TECHNICAL INFORMATION

95536
April 2012

Subject ▶ Change of Compression spring 3, Lock button

For Models ▶ BHR242, BHR243, LXRH01, LXRH02

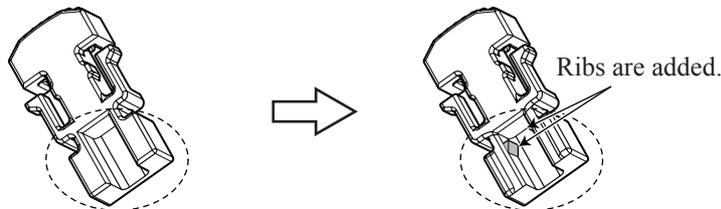
① The length of Compression spring 3 has been changed to 25mm from 40mm.

<How to assemble the new parts>

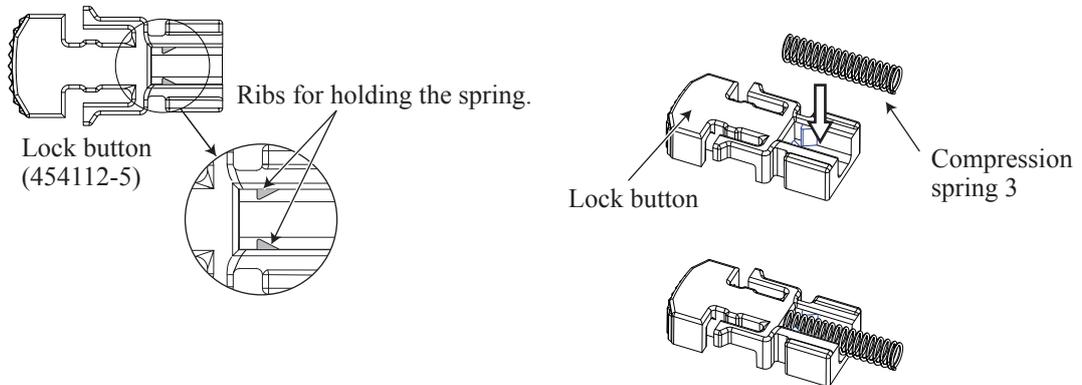
② The shape of Lock button has been modified.

- Fix Compression spring 3 to the place where between the ribs of Lock button.
